APPEAL SUMMARY

Appeal ID: 23789	Project Address: 3800 SE 164th Ave
Hearing Date: 6/10/20	Appellant Name: Hayley Purdy
Case No.: B-002	Appellant Phone: 503-896-5341
Appeal Type: Building	Plans Examiner/Inspector: Alice Johnson, Thomas Ng
Project Type: commercial	Stories: 3 Occupancy: R-2 Construction Type: V-B
Building/Business Name: Centennial Place Apartments	Fire Sprinklers: Yes - Throughout
Appeal Involves: Erection of a new structure	LUR or Permit Application No.: EA #19-201053
Plan Submitted Option: pdf [File 1] [File 2] [File 3] [File 4] [File 5]	Proposed use: Multi-family

CENTENNIAL PLACE APARTMENTS

8 STAIR 1 - THIRD FLOOR PLAN
3/8" = 1'-0"

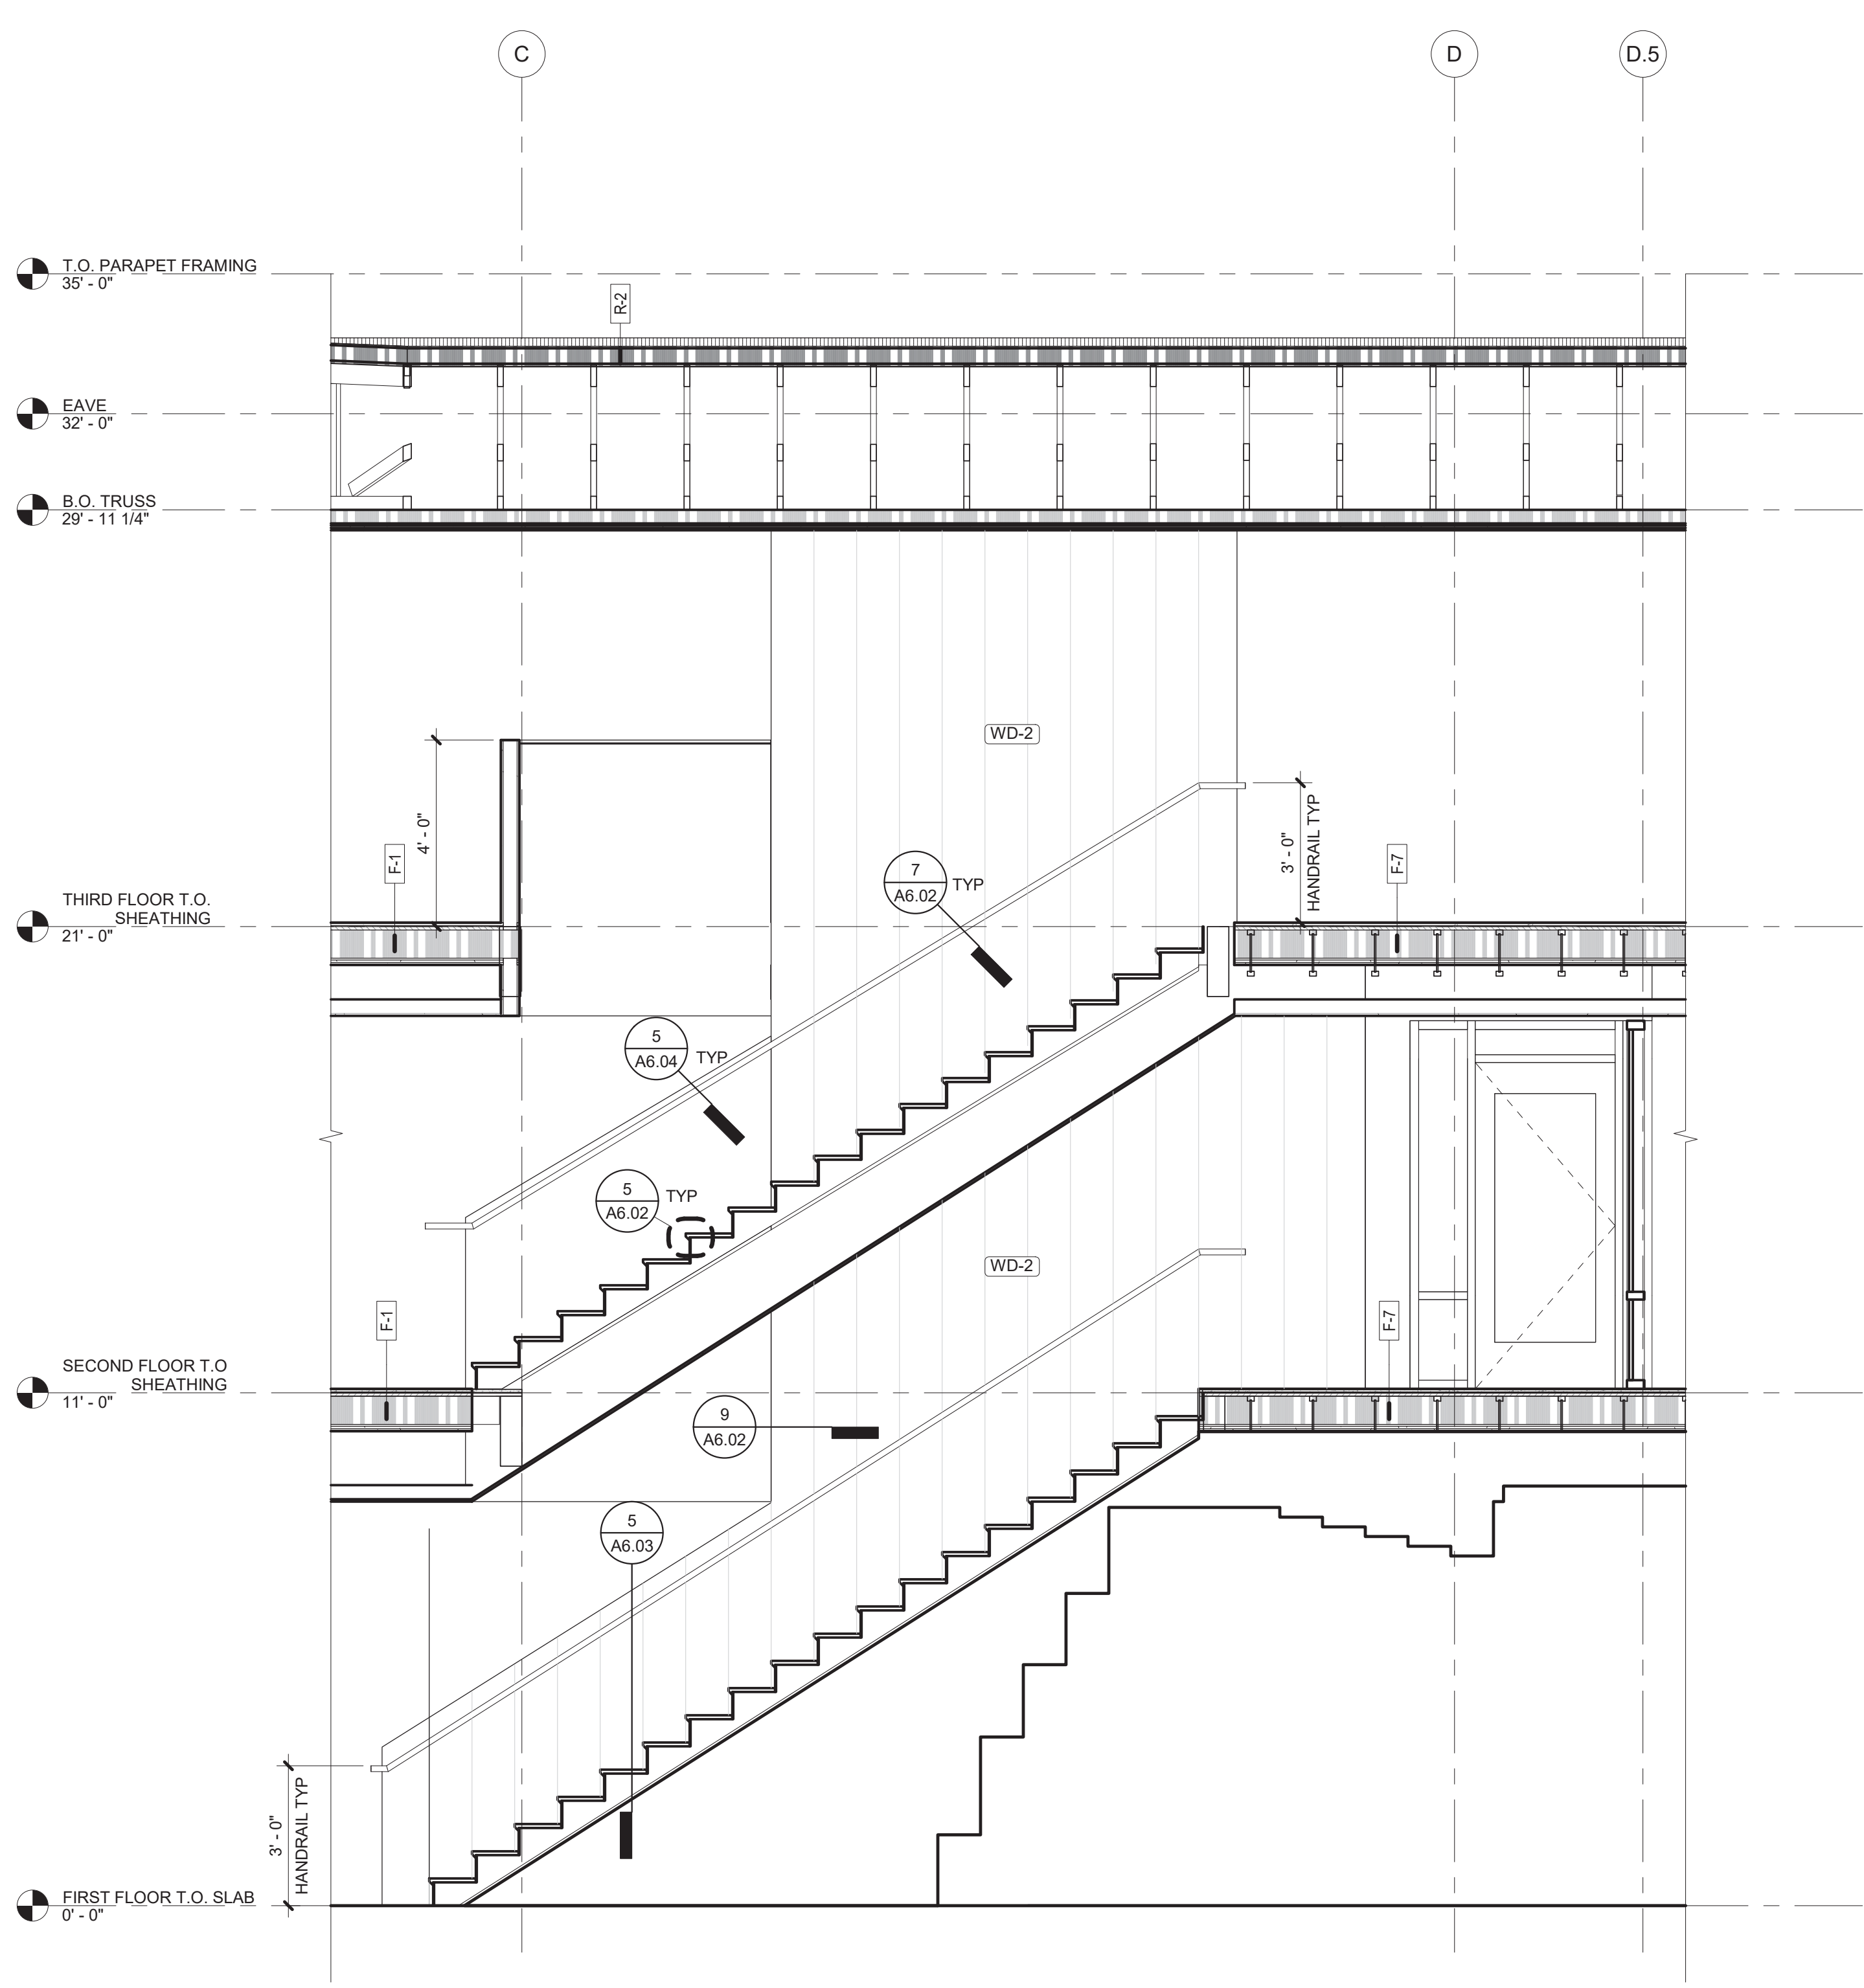
Code Modification or Alternate Requested Allow for a 2 story vertical opening containing an exit access stairway in accordance with section 1019 at Stair S1.

Proposed Design Our interpretation of the code, similar to the IBC commentary, references sections 712.1.12 and 1019.3 of the OSSC 2019. These sections of the code allow us to provide the two-story opening, between the first and second floor at Stair S1.

Stair S1 is not a path of egress in the building's exiting strategy. Two additional staircases are provided, Stair S2 and S3, with adequate exit access travel distance. Therefore, Stair S1 qualifies as an Exit Access Stairway which is section 712.1.12. If BDS agrees with the IBC Code commentary, then 712.1.9 would not supersede 712.1.12 and a three story opening is allowed.

- An open stair in the main lobby that encourages tenants to use the stairs instead of using the elevator. The stair is part of owner's goals for providing tenants with healthy-living opportunities. The health, accessibility, life safety and fire protection requirements are met as required with these conditions:
- Exiting provides life safety measures more than what is required by code.
- In the event of a fire, or presence of smoke, the monitored smoke detection system will immediately send an activation signal to the central monitoring system, notify the fire department and alert building occupants.
- Stair S2 and S3 are provided and more than adequately meet exit access travel distances. Stair S1 is not necessary for exiting requirements.
- Stair S1 is enclosed at the top of the second floor landing, and will be protected from the corridor by a unrated wall and accessible door.

4. Open exit access stair in main lobby: Granted provided sprinklers and draft curtains per OSSC 1019.3, condition 4 are installed at the 2nd floor ceiling level and the door is 20 minute rated with a closer.

**SANITARY / WATER /
FIRE PLAN**

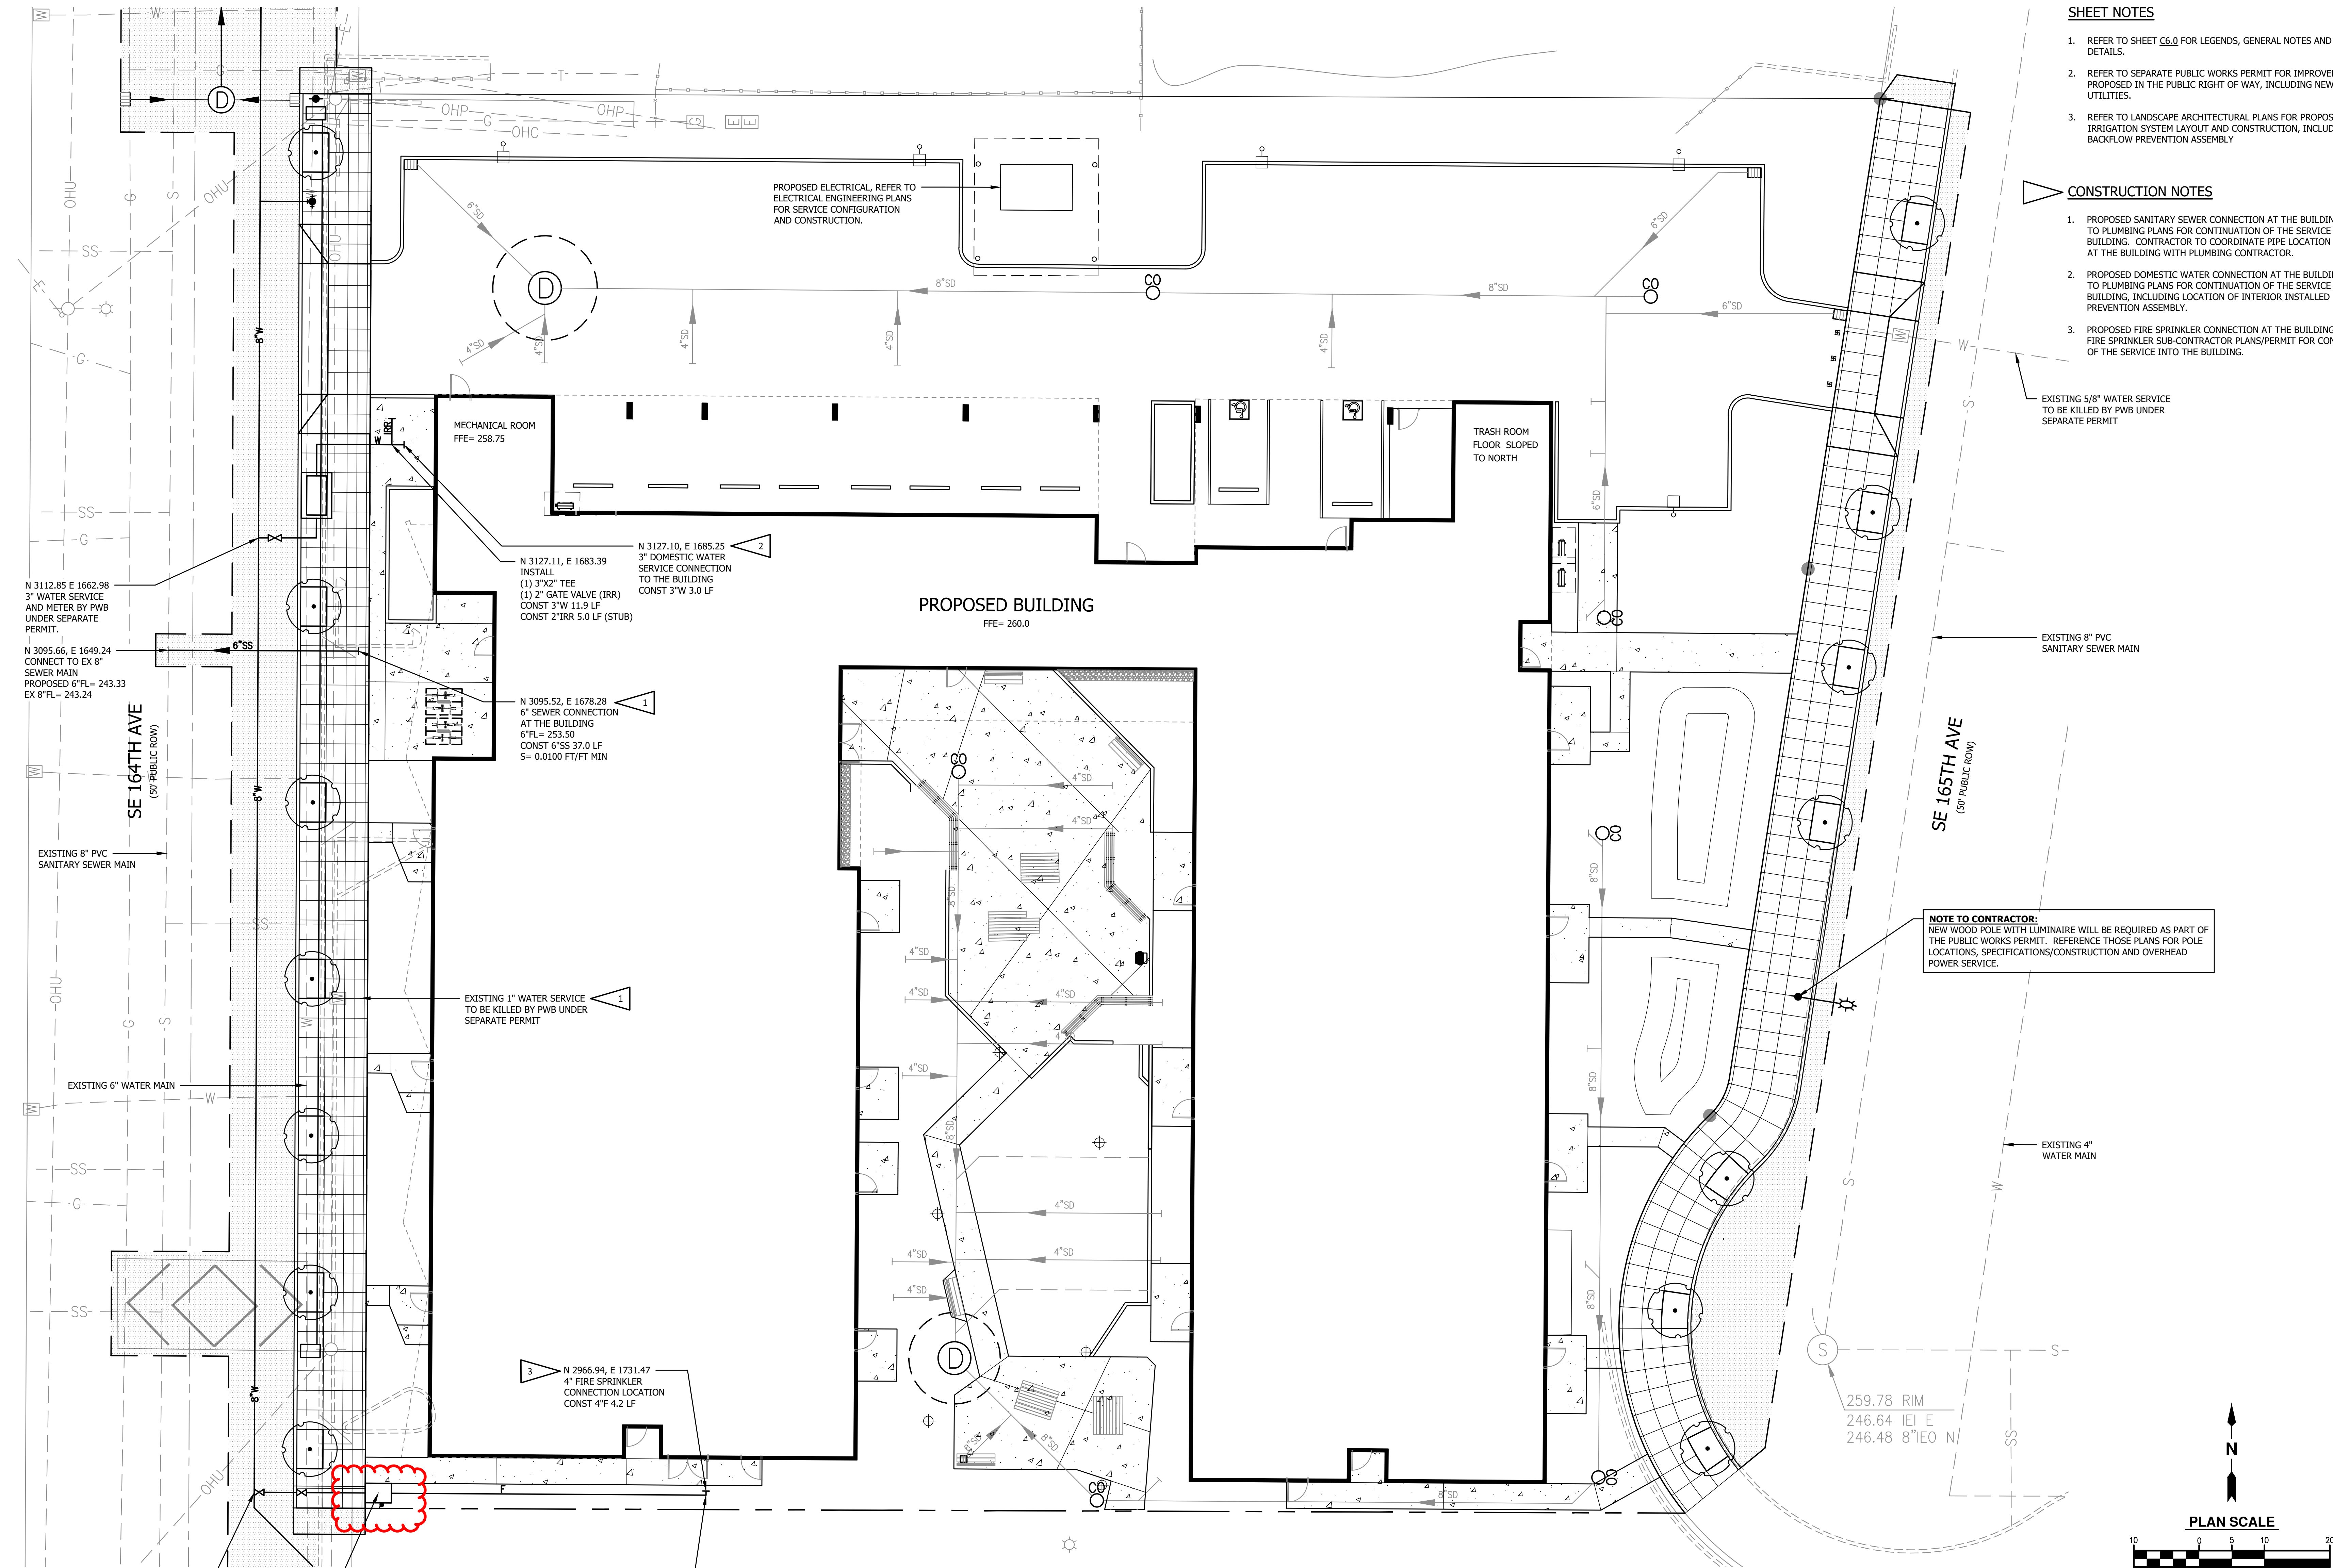
Code Section	Hydrant and Sprinkler Regulations
Requires	150' Rule for Hydrant Location Per PF&R design Manual, a public hydrant shall be located within 150' of FDC except as allowed by the Fire Marshall
Code Modification or Alternate Requested	With the addition on a new fire hydrant and the existing fire hydrant, the FDC is still further than 150' from the nearest fire hydrant.
Proposed Design	Use New and Existing hydrants: #1 Existing Hydrant located 170' south on SE Powell and SE 164th Avenue #2 New Hydrant located 200' north on SE 164th Avenue
Reason for alternative	• Building sprinkled and alarmed • Installation of proposed hydrant, new FDC and existing hydrant are sufficient.

2. Increase in maximum allowable distance of public hydrant from FDC from 150 feet to 170 feet: Granted as proposed.
